Approval and Review Comments

LANDSCAPE PLAN

NEW DEVELOPMENT
WASHINGTON TRUST BANK
2019 16TH AVE
LEWISTON, ID 83501

L1.0

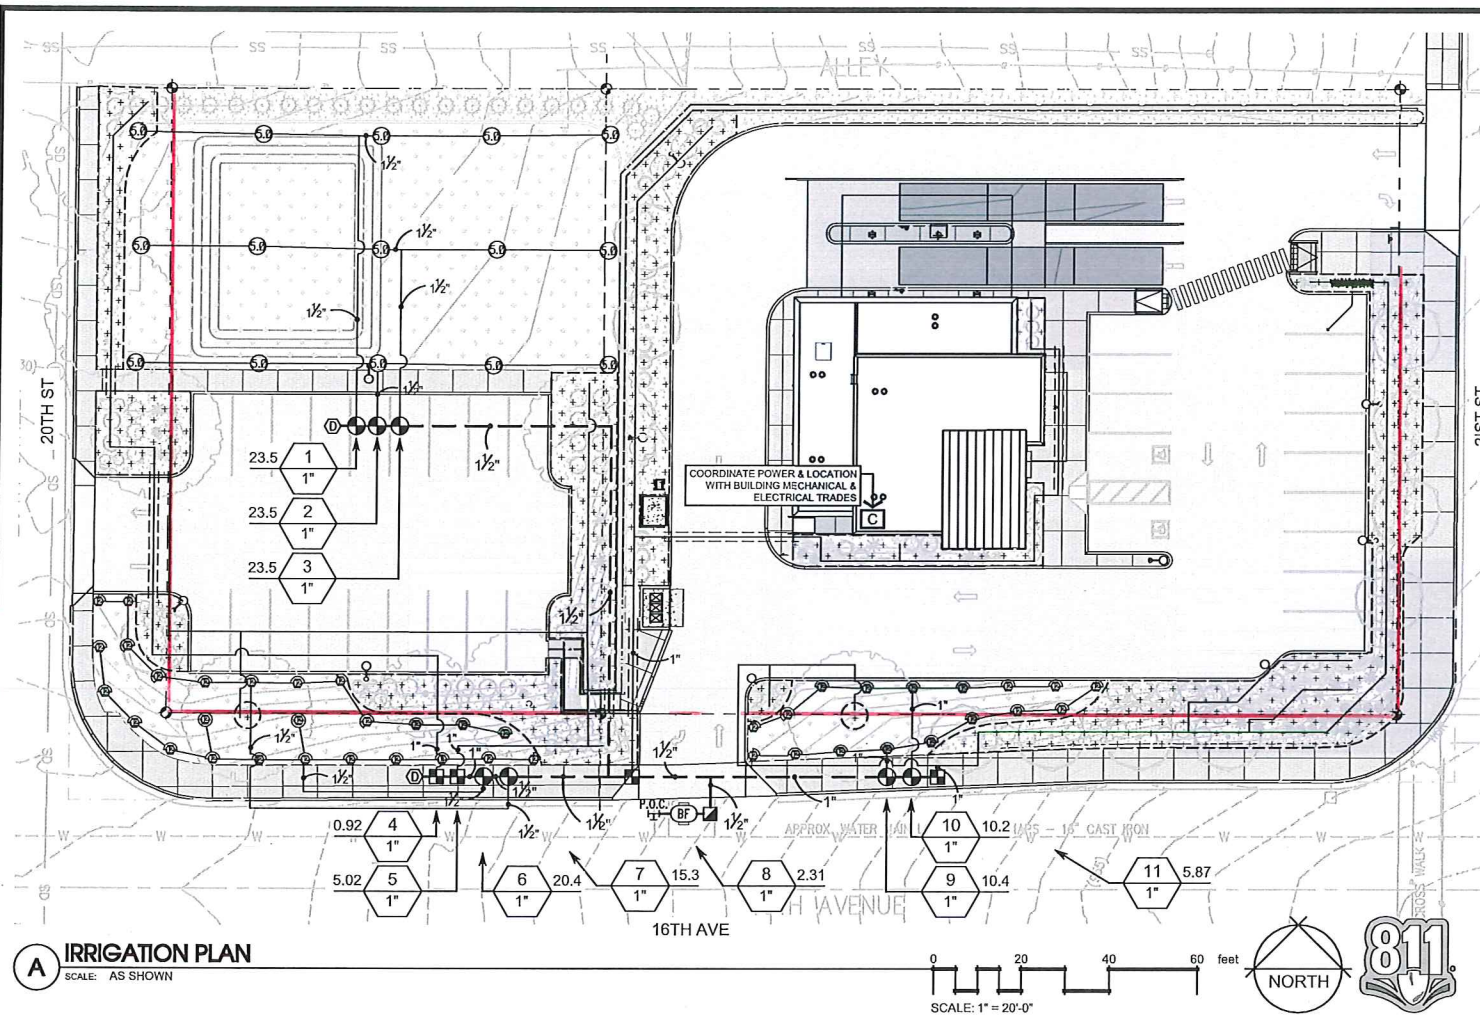
Comments: See attached Review Comments from previous grading submittal and respond to each comment not yet addressed. Stormwater Report is reviewed and approved. Label property boundaries and provide legal description for ROW dedication. Label any signage needed for approach turning movement restrictions (ie Right turn only). Landscaping in the ROW will require an encroachment permit. Feel free to call and discuss these comments anytime. PS *please include fence and irrigation system 21st, 16th Ave + 20th st*

frontage in encroachment
